JOYFUL VIEW SUBDIVISION
OGC RE2, LLC.
EL PASO COUNTY, CO

JOYFUL VIEW SUBDIVISION CONSTRUCTION DOCUMENTS

PCD FILING NO. SF2231

CONSTRUCTION DOCUMENTS
FOREBAY DETAILS

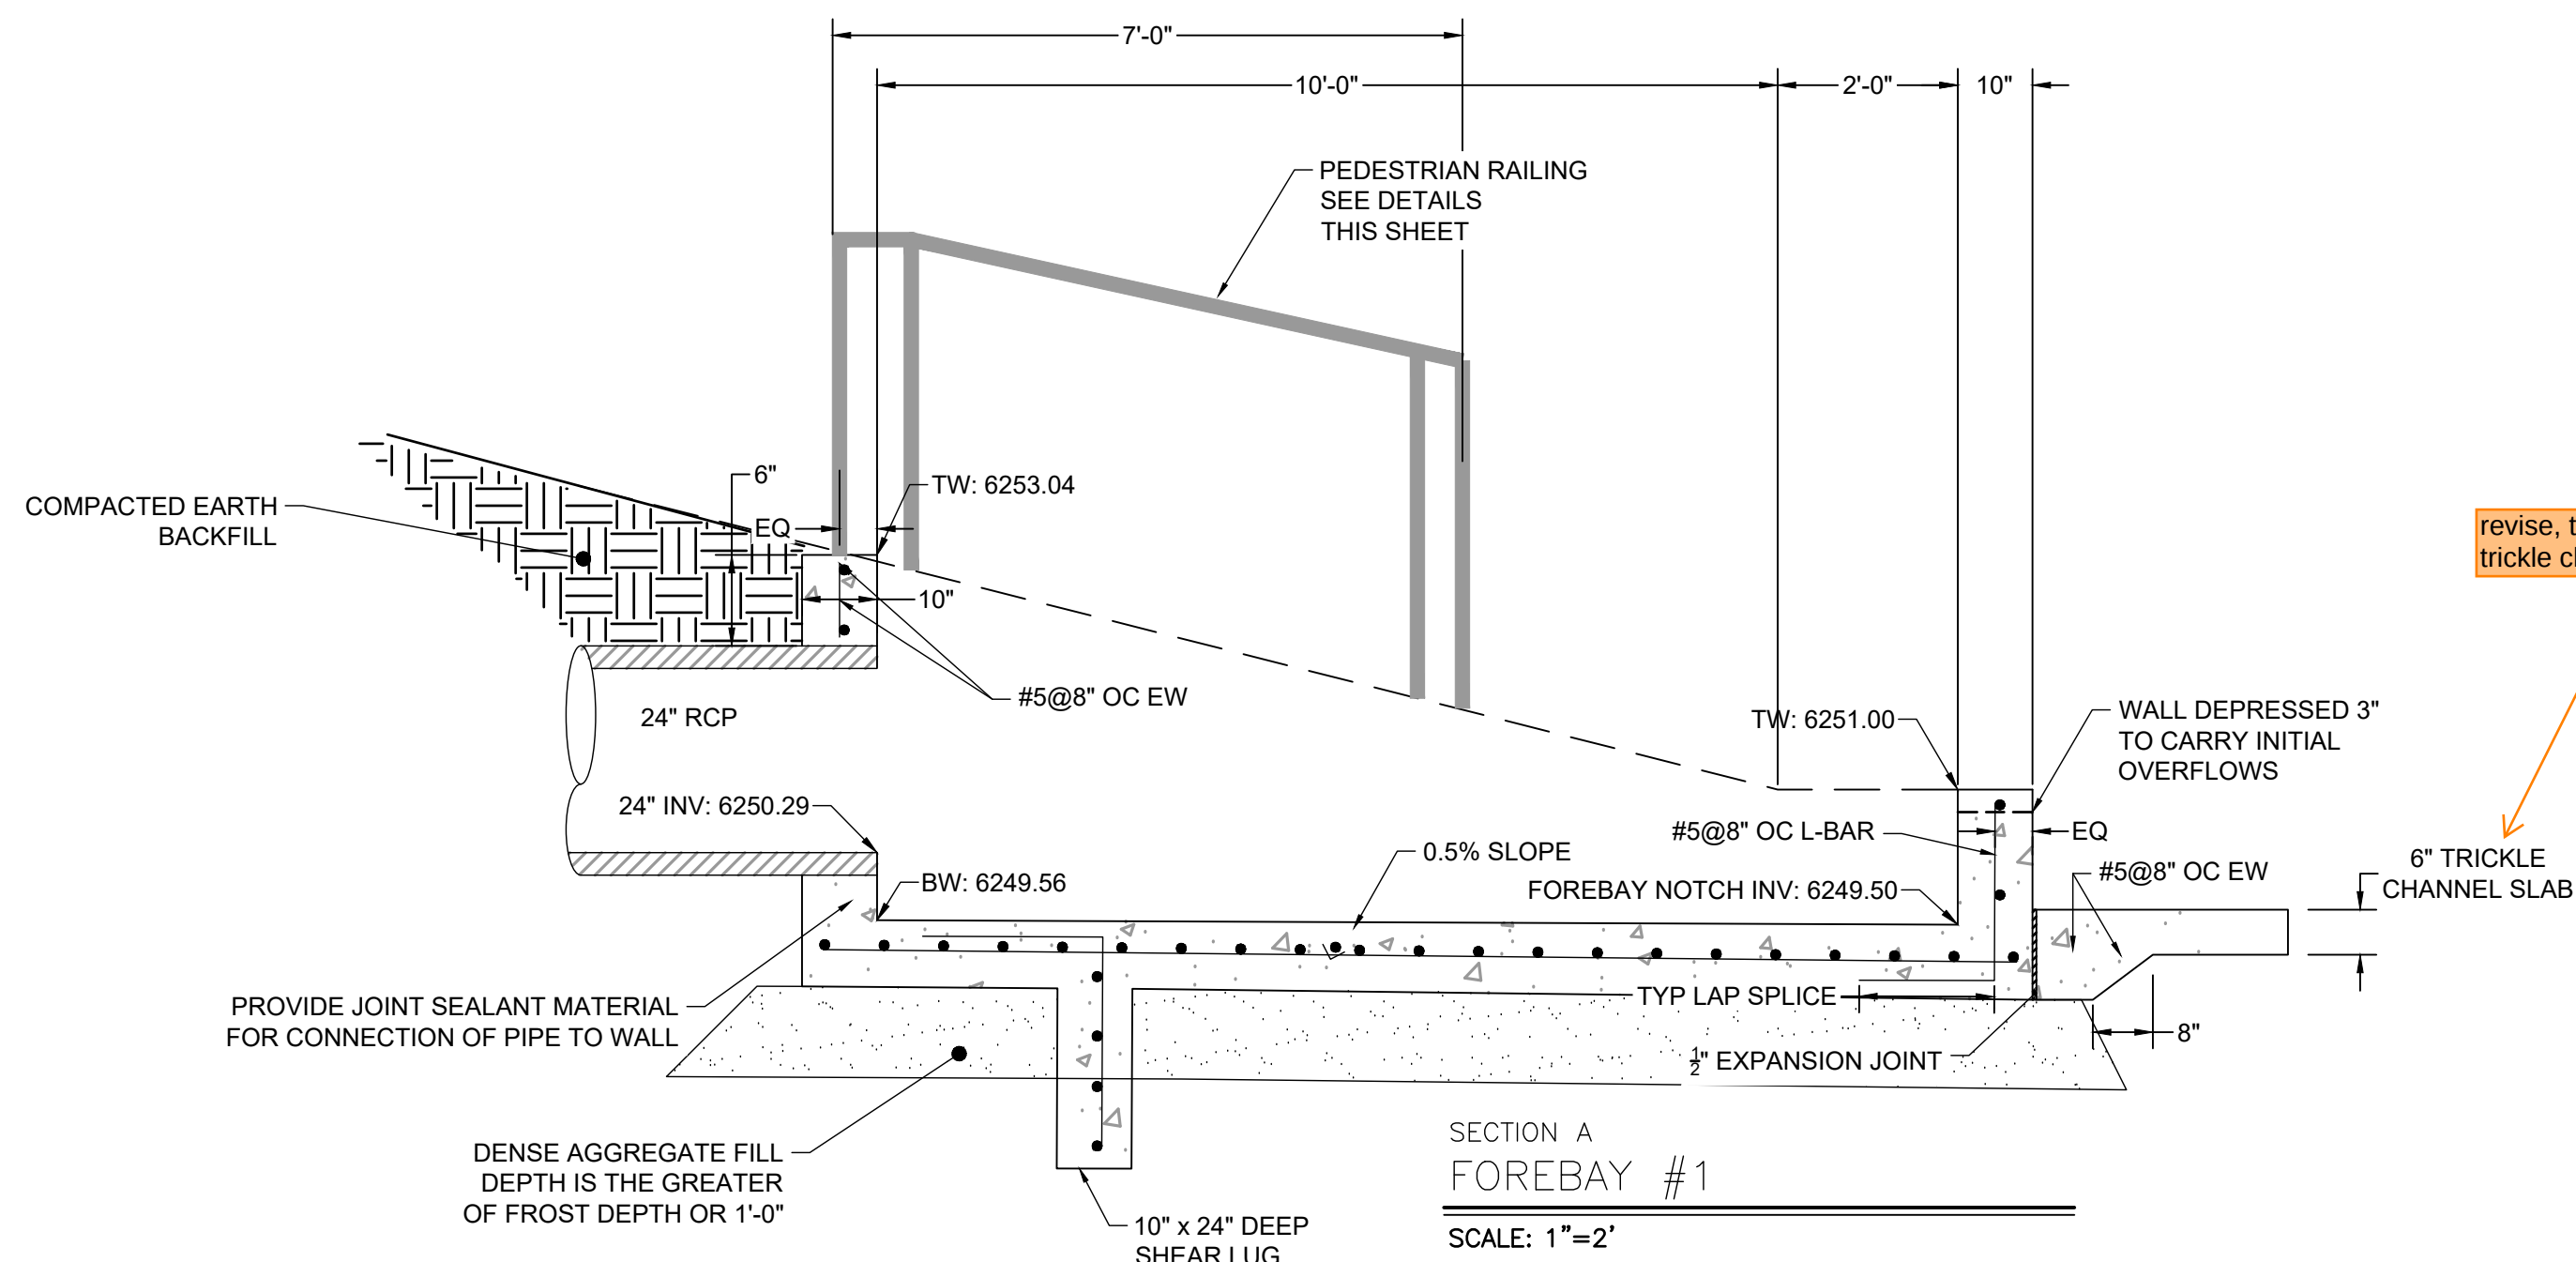
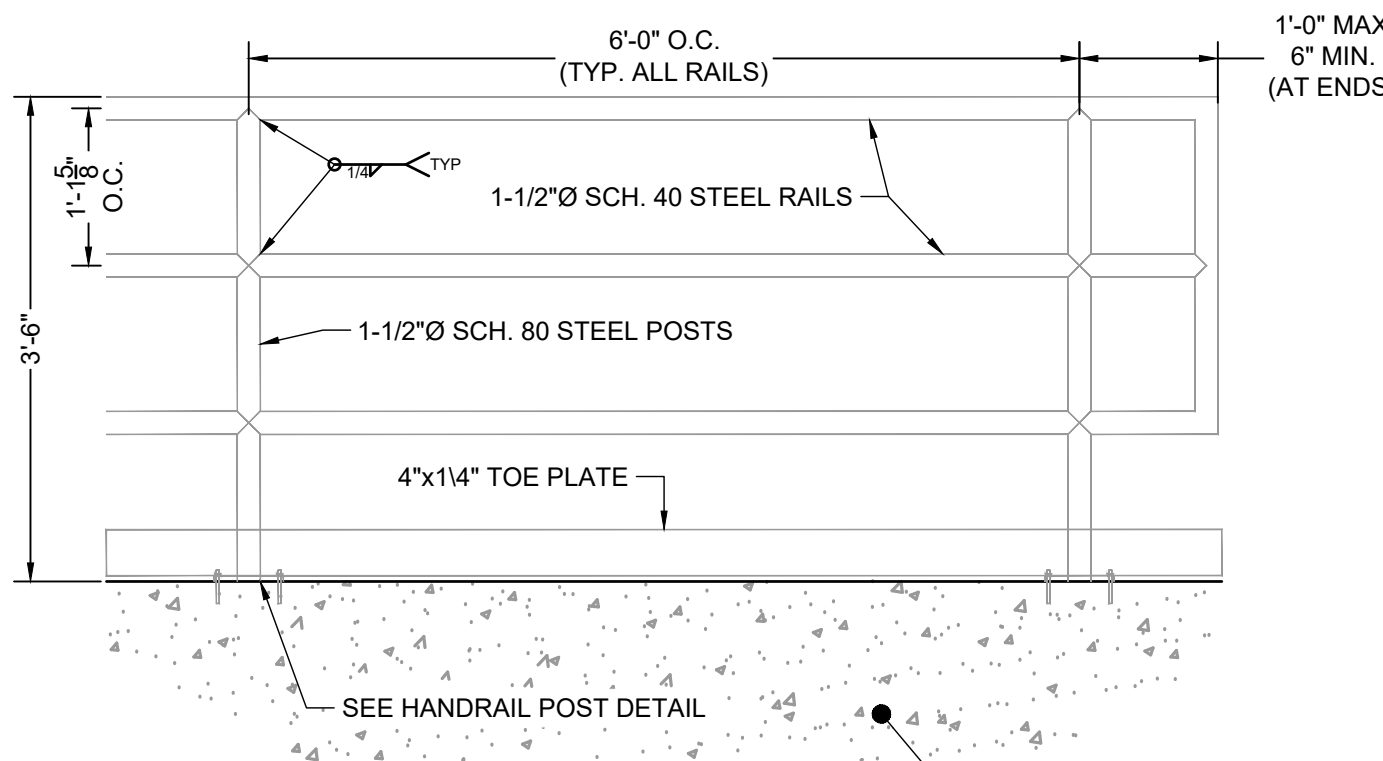
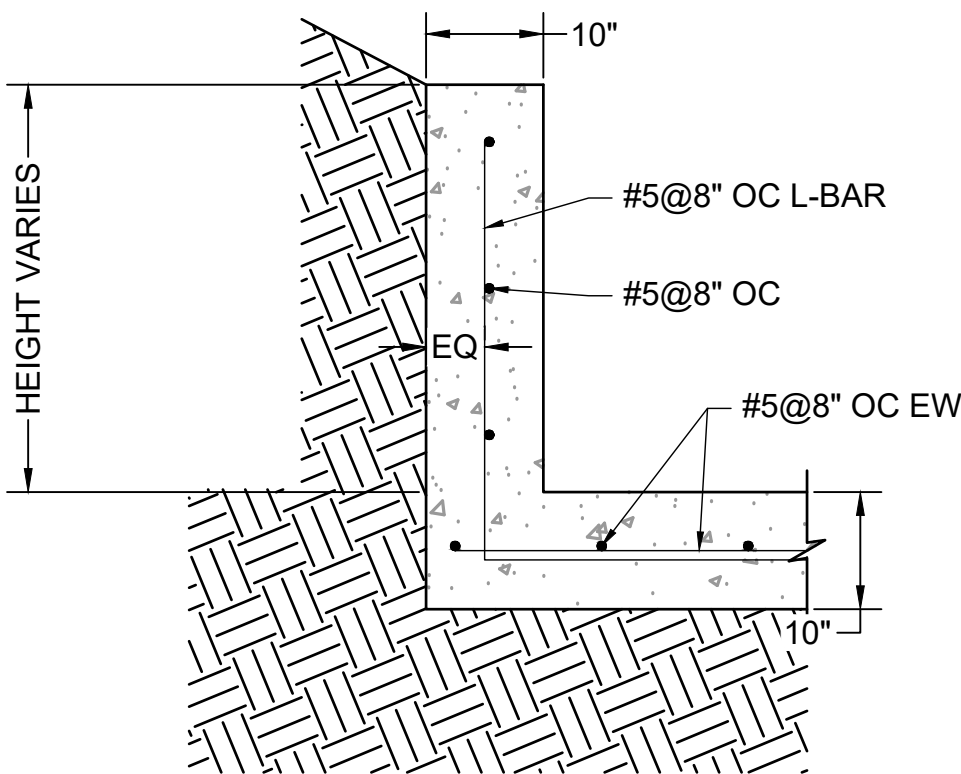
Per recent conversation with Richie, highly recommend revising this to soil riprap since it is just going to get filled with sediment from storms anyway. Soil riprap is much easier to maintain.

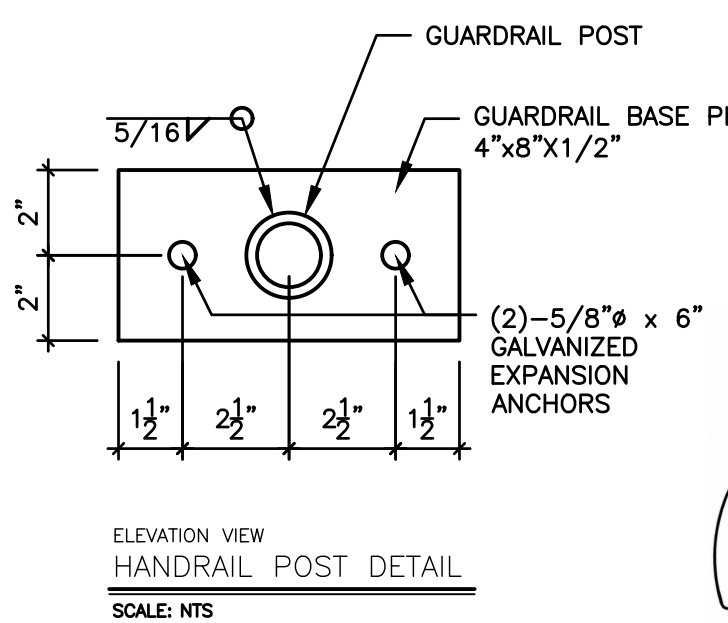
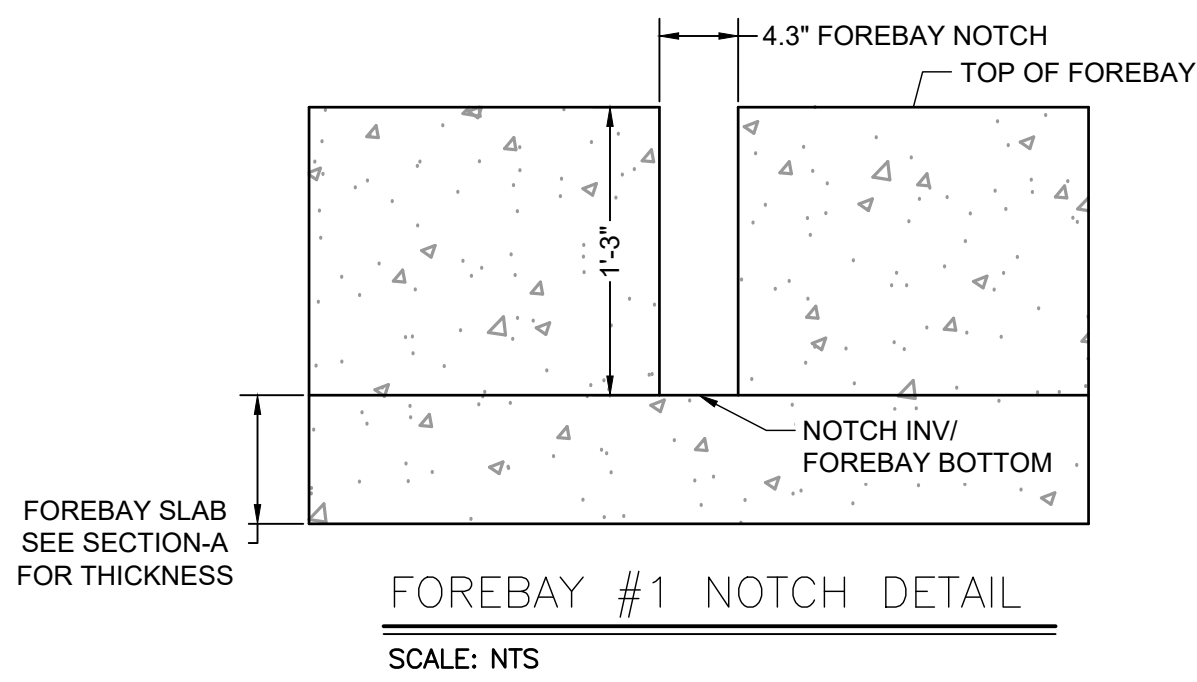
revise, there is not a trickle channel.
